# United States Patent and Trademark Office

APPLICATION NO.	FILING DATE	FIRST NAMED INVENTOR	ATTORNEY DOCKET NO.	CONFIRMATION NO.
10/020,275	12/18/2001	Walter Takeo Yagyu	08200.608	9120
75	90 04/02/2003			
Liniak, Berenato, Longacre & White Ste. 240 6550 Rock Spring Drive			EXAMINER	
			FERGUSON, MICHAEL P	
Bethesda, MD 20817			ART UNIT	PAPER NUMBER
			3679	
			DATE MAILED: 04/02/2003

#### **DETAILED ACTION**

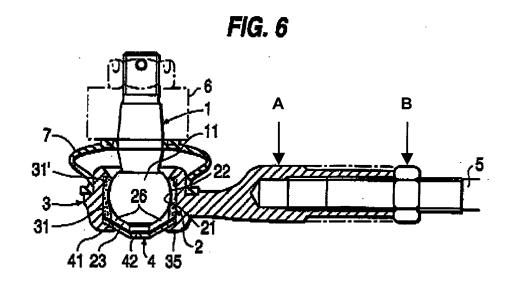
As to claim 1, Shimizu et al. discloses a tie rod with application of polymer composite with fiber reinforcement, having a stem 5 provided at its ends with ball joints 3 each composed of a box A (Figure 6 reprinted below with annotations), a bearing 2, a protection cover 7 and a ball pin 1, the tie rod having the function of fixing pieces and components of a mechanical system between themselves, providing to them angular and rotational movement, supporting the strains concentrated therein, wherein the stem of the tie rod is combined with components of a metallic material provided in the ball joints (box A of ball joint 3 has a metallic cross-hatching; Figure 6).

As to claim 3, Shimizu et al. discloses a tie rod wherein ball joints 3 are attached to the ends of a stem 5 by means of a thread on the body of the stem and in the ball joints' boxes **A**, making the tie rod a tie rod with variable length, the adjustment of its length and the locking of the tie rod being provided by nuts **B** provided on the threads of the stem and that are tightened against the boxes of the ball joints (Figure 6).
